Response to National Grid (NG) Scoping Report¹

15 November 2022

Essex Suffolk Norfolk Pylons (ESNP) is the umbrella group for communities along NG's 180km 'East Anglia GREEN' (EAG) pylons route. Our petition, signed by 22,000, called for an offshore grid. On 16 June we submitted an 80-page response² to the non-statutory consultation. It detailed numerous environmental (and other) issues. With it we submitted a legal opinion³ from Charles Banner KC and a survey completed by 2,500 people⁴. We are yet to receive a response from National Grid. Our submissions have not been referred to or the issues addressed in the Scoping Report⁵ (SR).

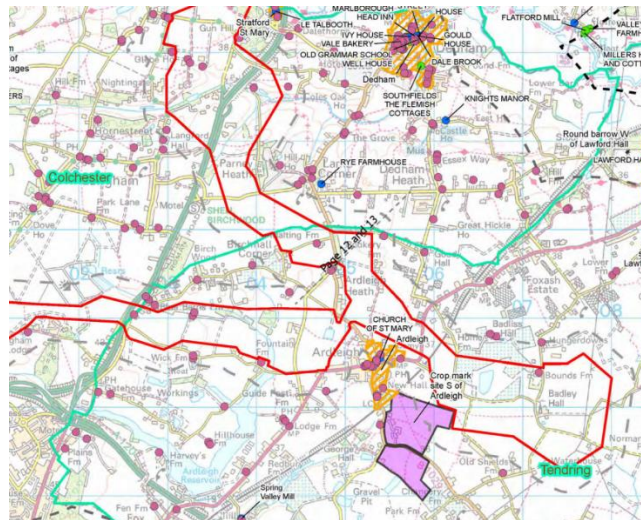
It is imperative, too, that the ES will consider the impact of the doubling back effect of pylons at Ardleigh, which leaves residents living in a 'V' of pylons:
